HSM-15005

SUBJECT: RESULTS FROM CONSULTATION WITH SUTTER CAC CONCERNING

WAREHOUSE FUMIGATIONS ADJACENT TO A PROCESSING AREA AT A

WALNUT PROCESSING PLANT

Photo One: Passageway view, both ends.

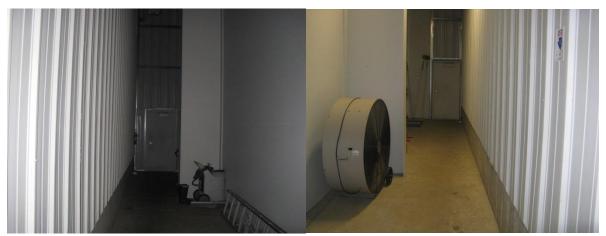
In Photo One, the smooth wall is the bulk storage; the corrugated wall is the processing/storage. The proposed commodity fumigation will use the bulk storage structure as an enclosure for the gas. The bulk storage structure wall in the passageway appears, on cursory examination, to be a sheer wall, with no obvious penetrations. The facility stated that the joints and other potential points of fumigant gas leakage have been properly sealed. However, imperfections in the wall

structures, the sealing procedures and other unknown integrity breaches could lead to fumigant gas accumulation in the passageway.

The worker Health and Safety Branch, Industrial Hygiene Services has the following recommendations for mitigating potentially hazardous conditions caused by fugitive emissions from the bulk storage structure during fumigation, aeration and post-aeration:

1. During the fumigation period, the label required aeration period, and for 48 hours post-aeration period, continuous aeration of the passageway should be performed. This can be accomplished by either two portable fans (capable of at least 12,000 cfm) located at each doorway in the passageway or by structurally-incorporated ventilators (equal in air moving ability to the portable fans) built into the wall-panels above the doors. A push-pull set-up of the fans should be used, directing air from the north end of the passageway to the south end. The north-end fan should bring in fresh air; the south end fan should be exhausting potentially contaminated passageway air. If portable fans positioned in the doorways are used, it is strongly recommended, to maximize air exchange efficiency, that wooden shrouds be fabricated to fit in the doorways, to act as hoods for the fans (see example Photo Two).
